Groundwater Application Review Summary Form

Application # G- 18485

PUBLIC INTEREST REVIEW FOR GROUNDWATER APPLICATIONS

TO: Water Rights Section Date June 29, 2017
 FROM: Groundwater Section Aurora C Bouchier
 Reviewer's Name
 SUBJECT: Application G- 18485 Supersedes review of na
 Date of Review(s)

Water-Level Trends in Nearby Wells

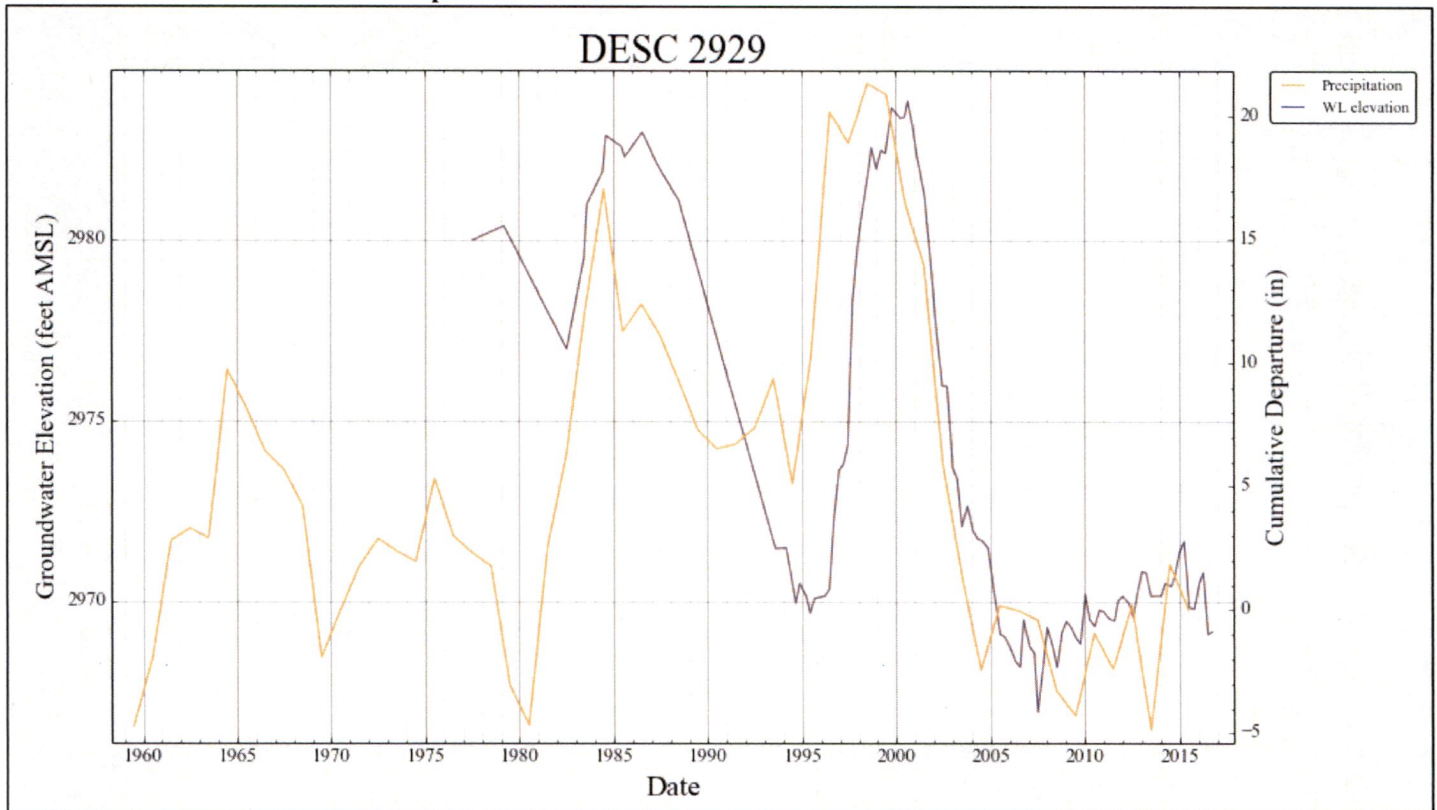
The nearest State Observation Well (DESC 3193) is located approximately 2.7 miles to the west, unfortunately measurements at this well ceased in 2005. The nearest State Observation Well currently being measured, DESC 2929, is located approximately 6 miles to the northwest. Some measurements exist for wells located within the same section as the applicant's well. During the periods of overlap, the hydrograph of DESC 3193 and DSC 2929 show a similar pattern. Historically, the wells appear to have been in dynamic equilibrium. The long-term trends show a decadal-scale water level fluctuation that is coincident with climate cycles at Sisters. The decadal fluctuation has a maximum amplitude of approximately 15 feet. Since 2000, the water level has dropped about 15 feet, with a slight increase since 2005.
